REF.	DESCRIPTION.	DATE.
A	Precast Concrete kerbs replaced with Marshalls Kerbs (10' MB & 85 RM)	28.07.05

CLIENT:
Broadgate Homes Ltd

TITLE:
Lincolnshire County Council
Block Paved Constuction Minor Road and Footway Sections

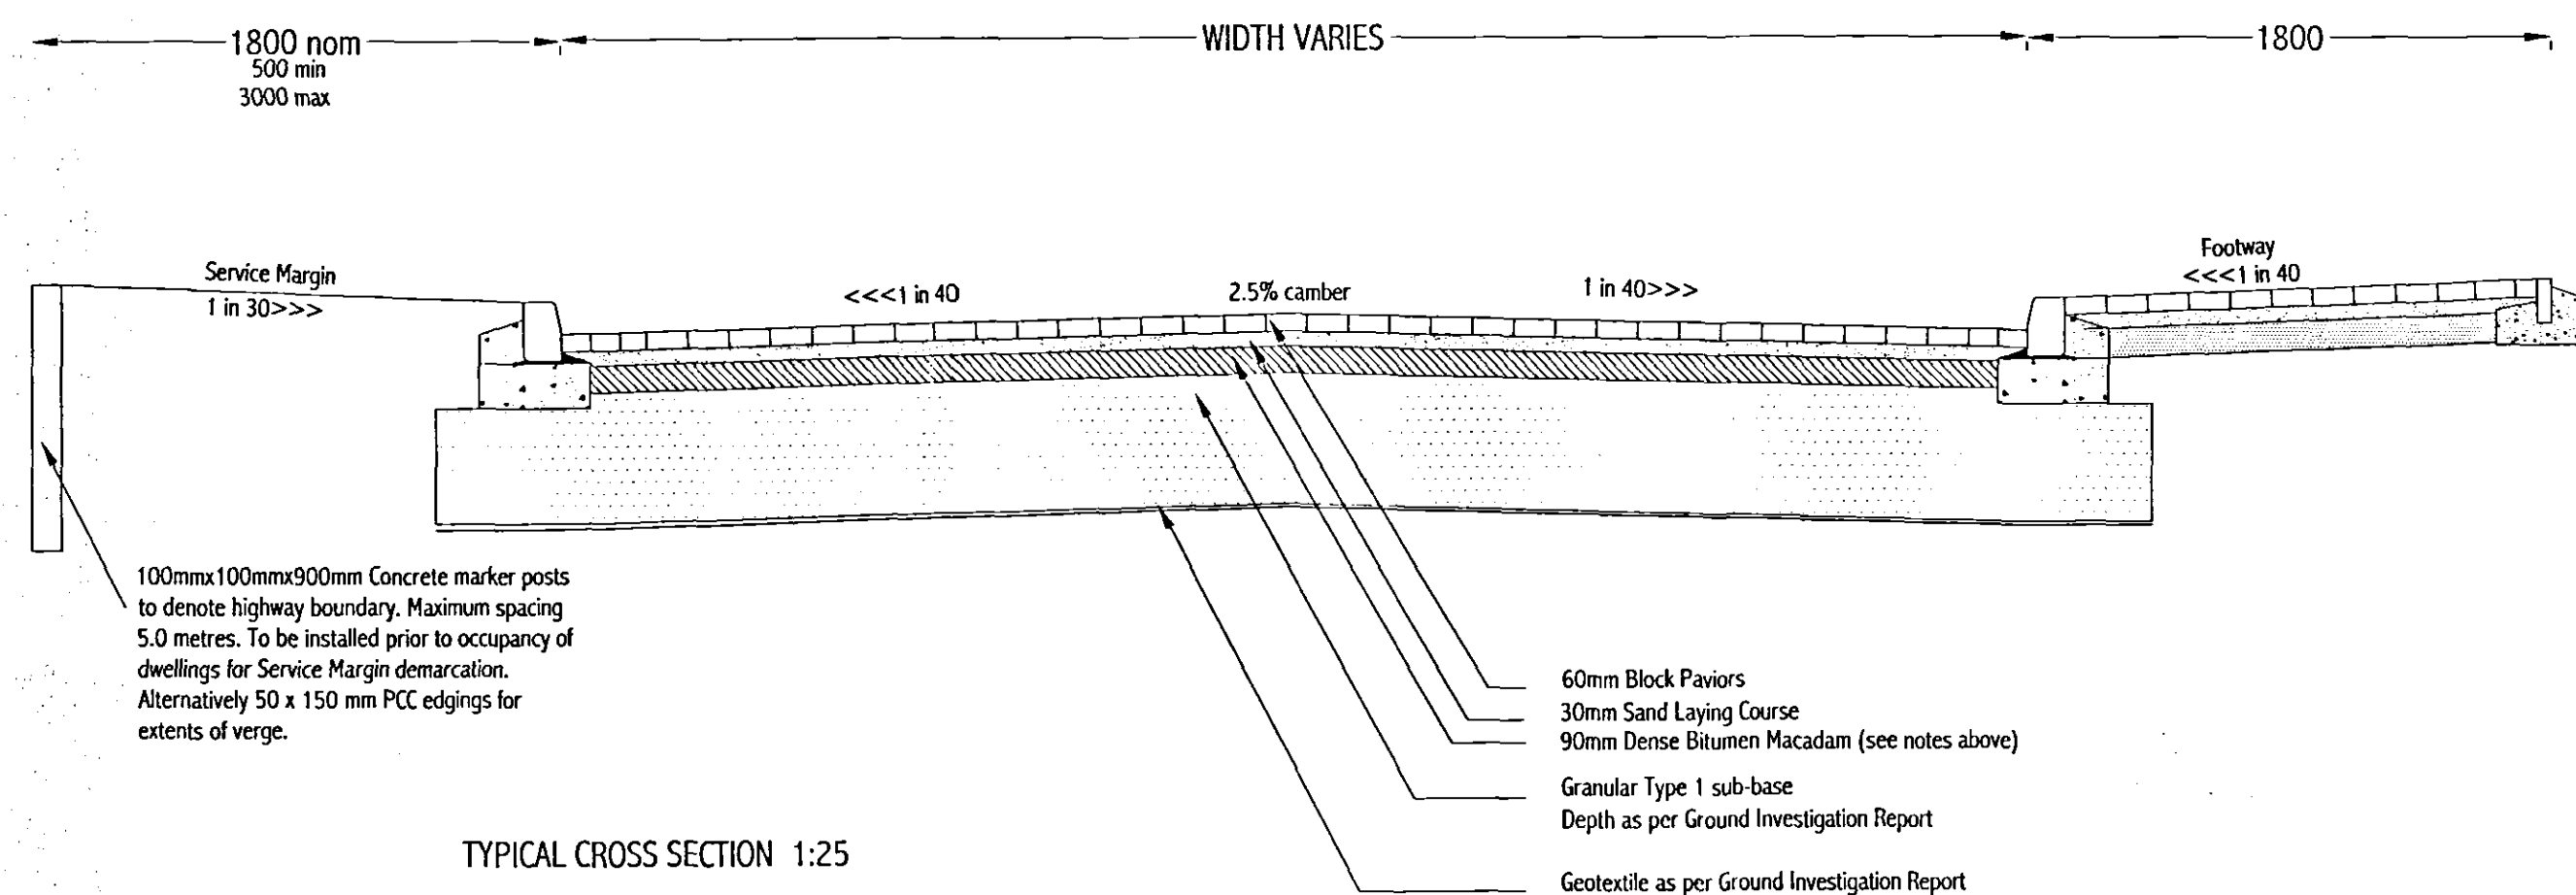
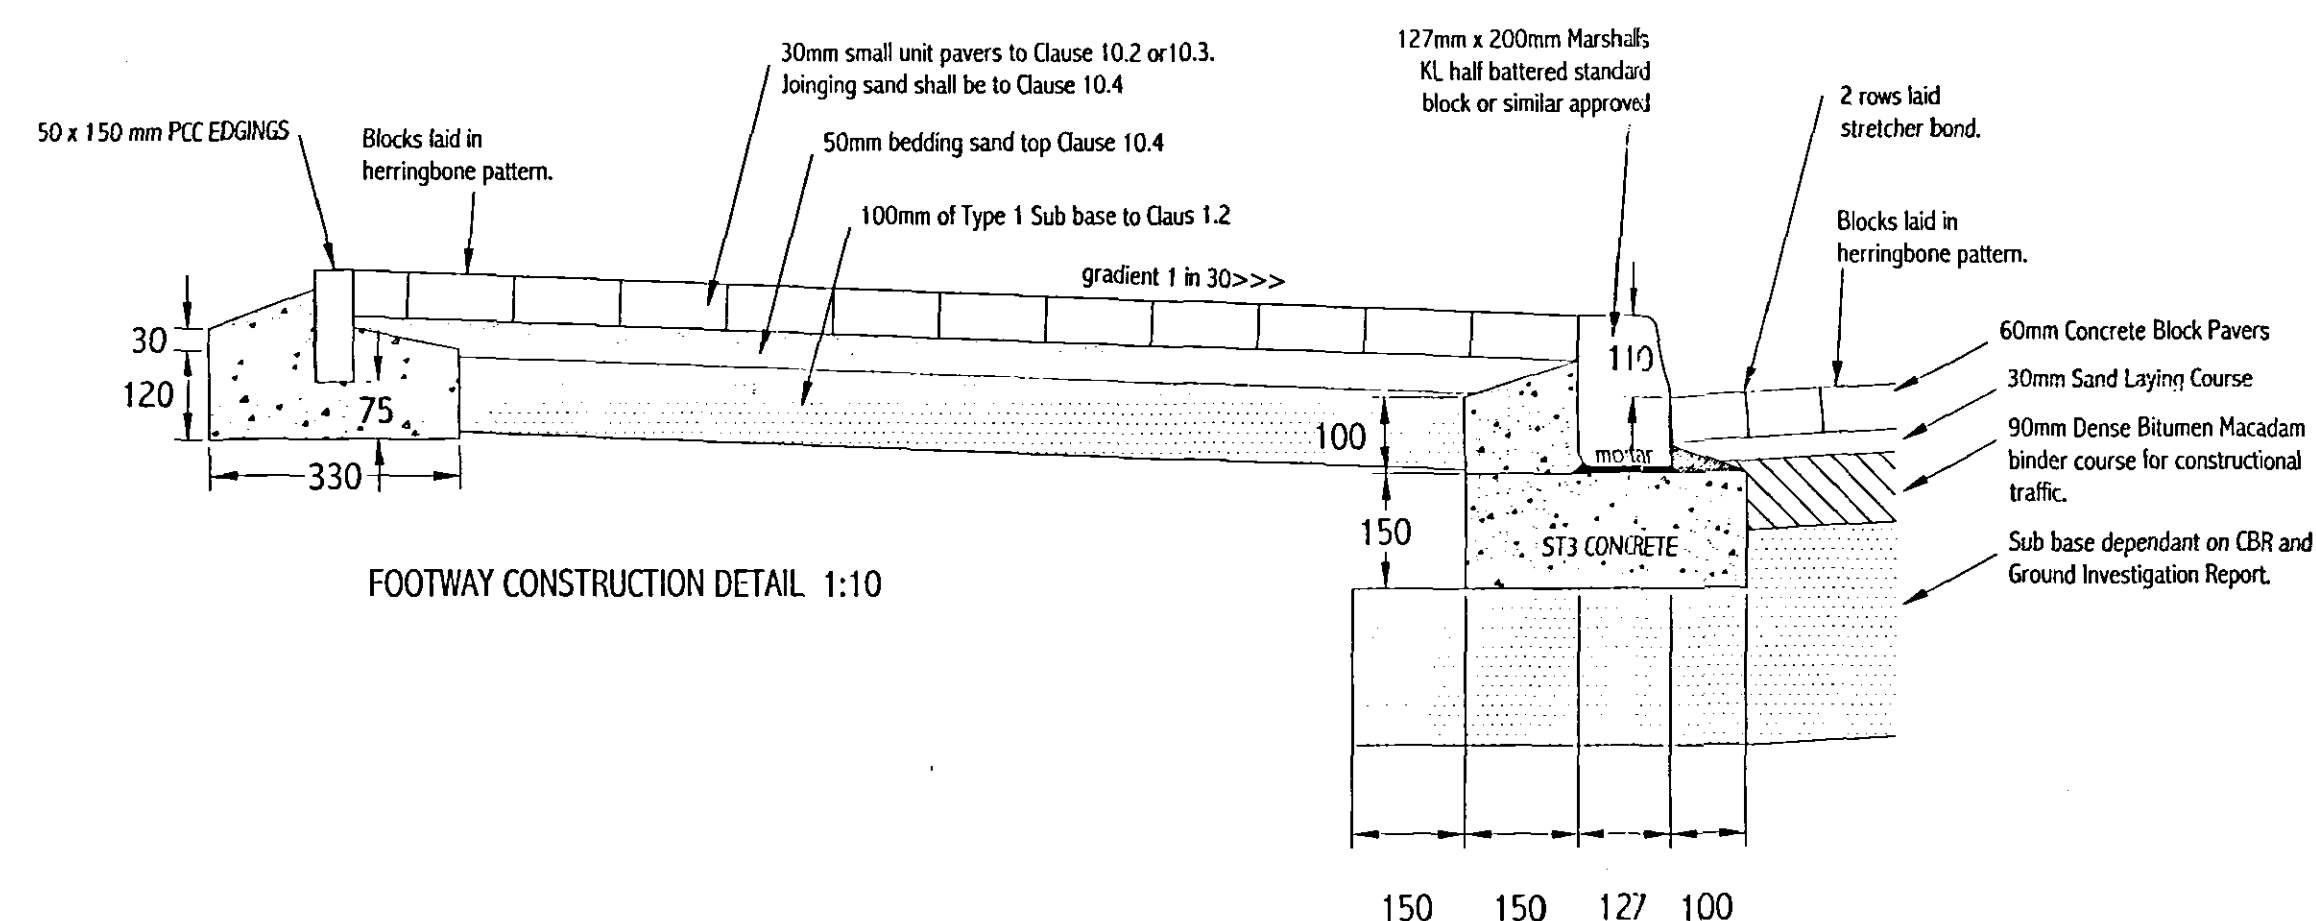
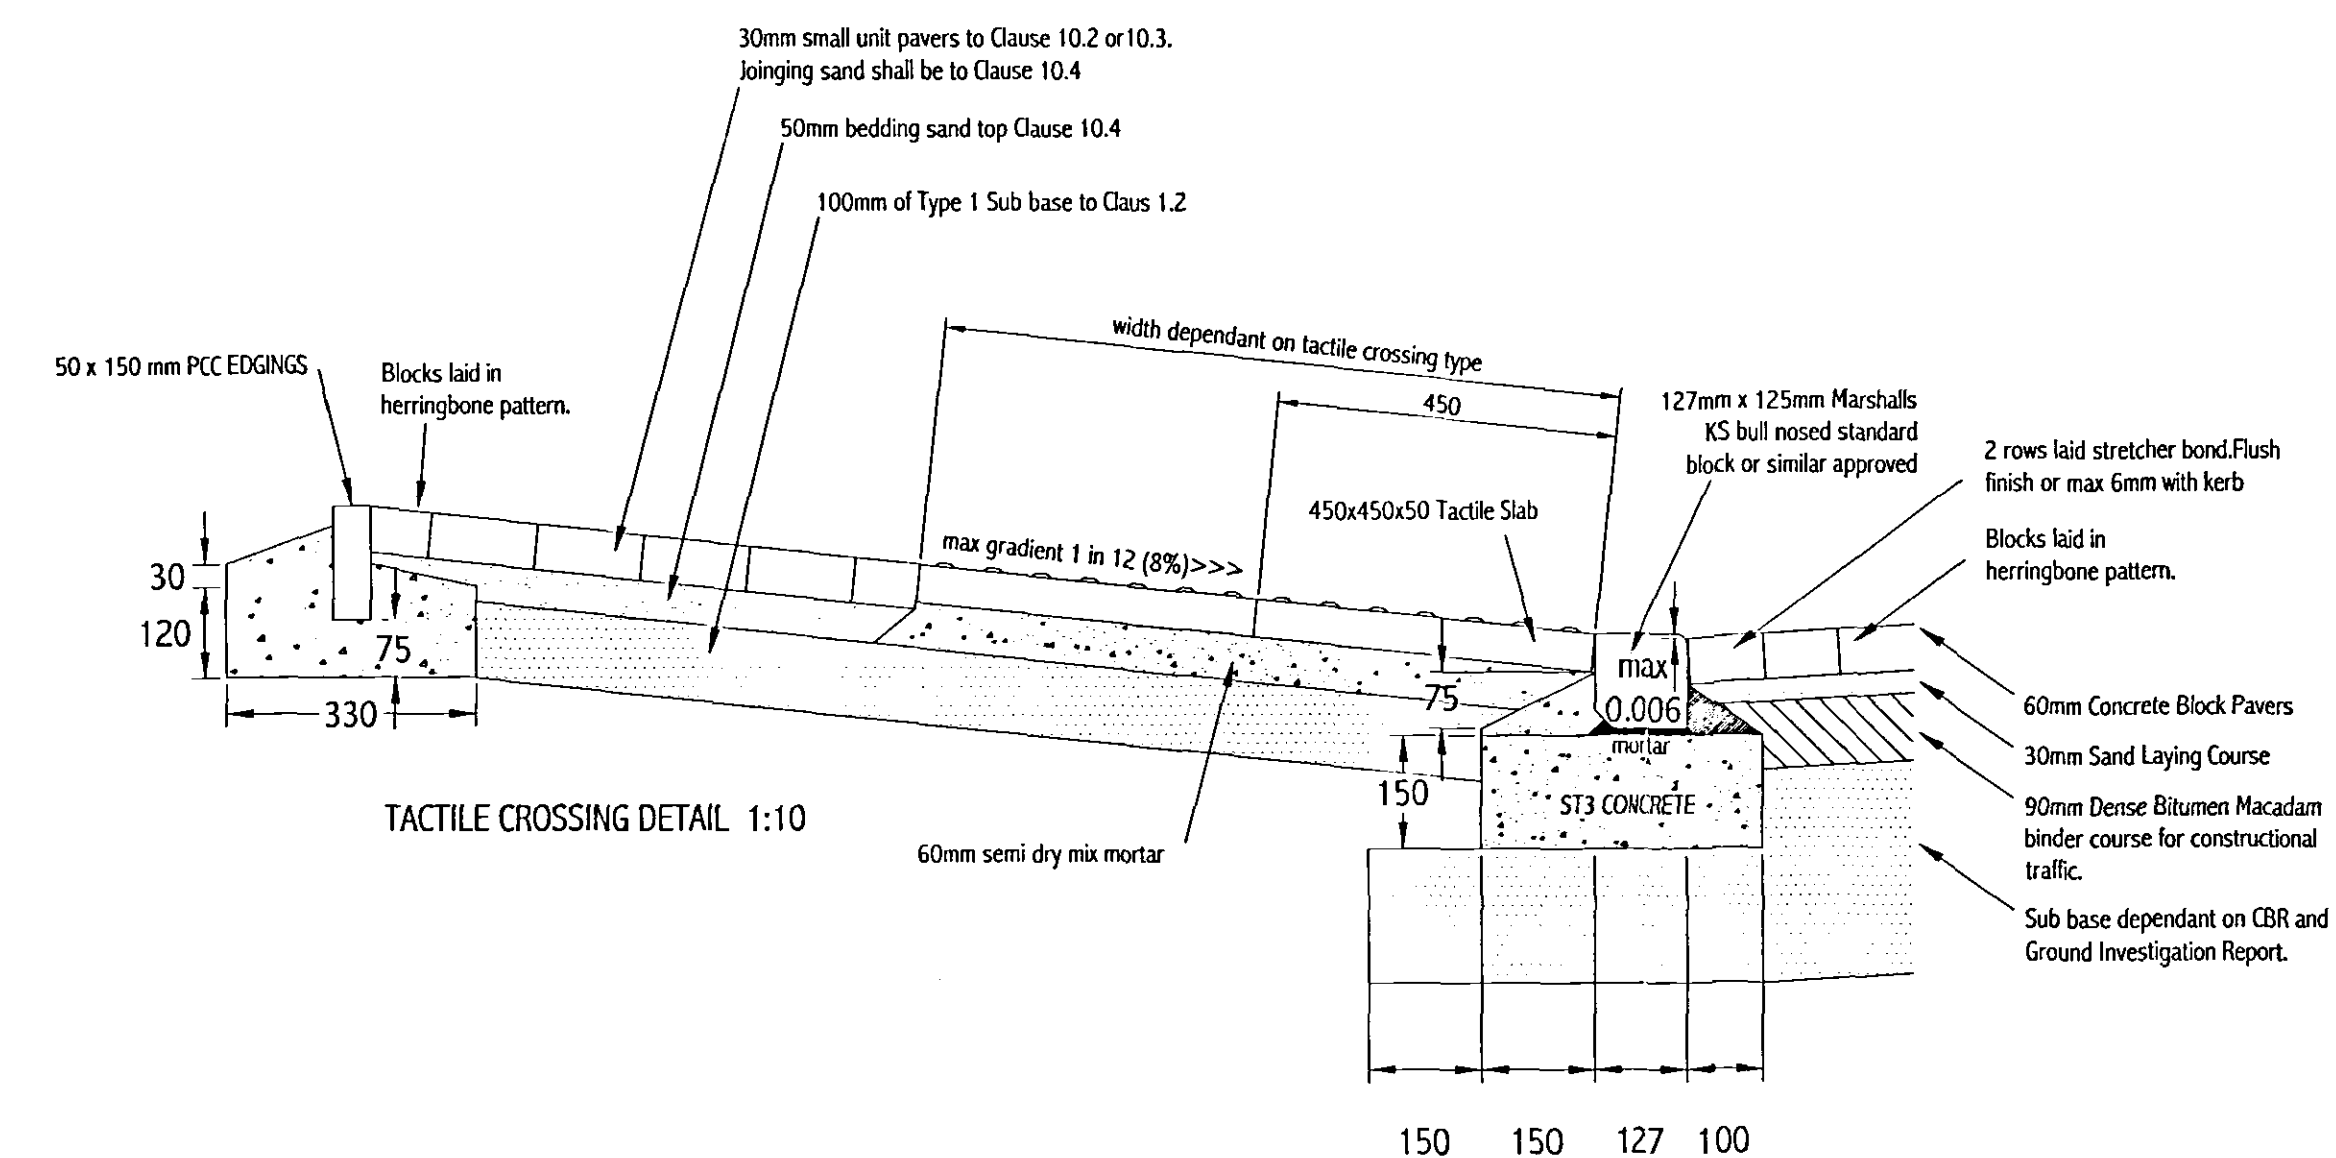
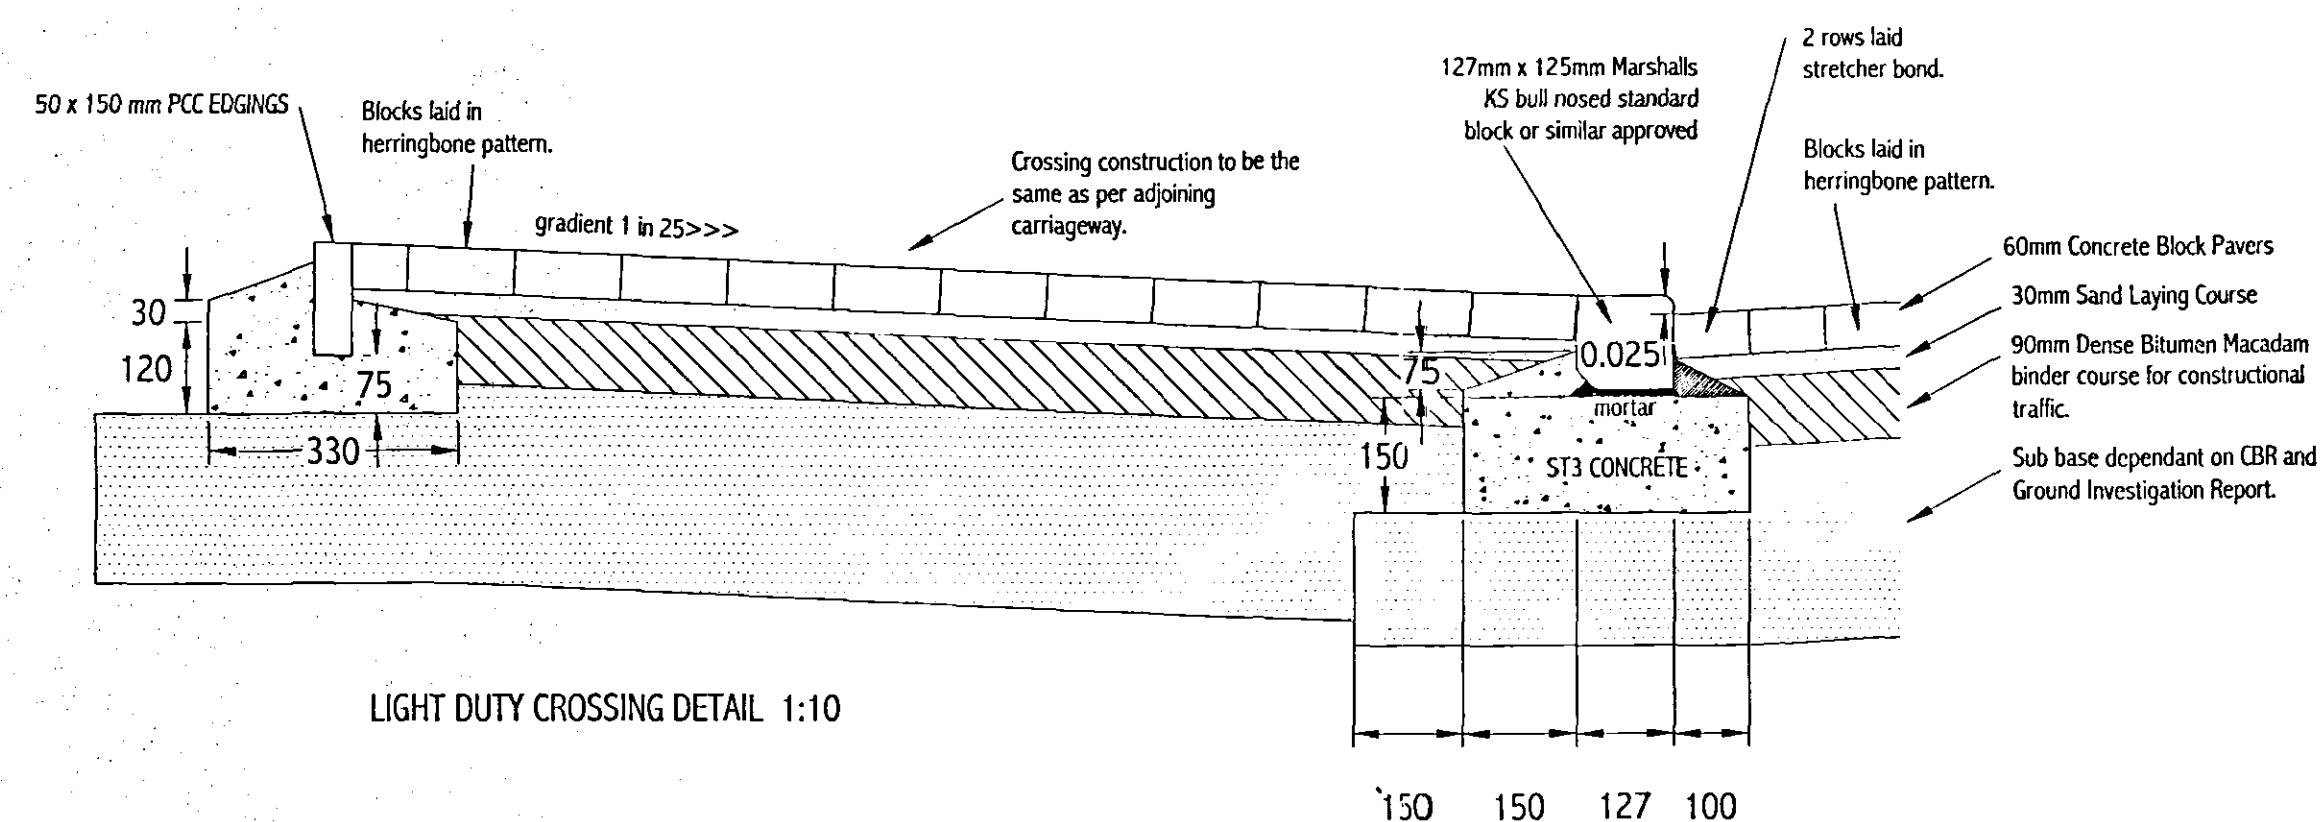
PRECAST CONCRETE UNIT KERBS ARE NOT TO BE USED
AND SHOULD BE REPLACED WITH MARSHALLS KL HALF
BATTERED STANDARD BLOCK OR KS BULL NOSED
STANDARD BLOCK OR SIMILAR APPROVED AS AGREED
AND INSTRUCTED BY DEAN WHITEHEAD OF
LINCOLNSHIRE COUNTY COUNCIL 27.07.05
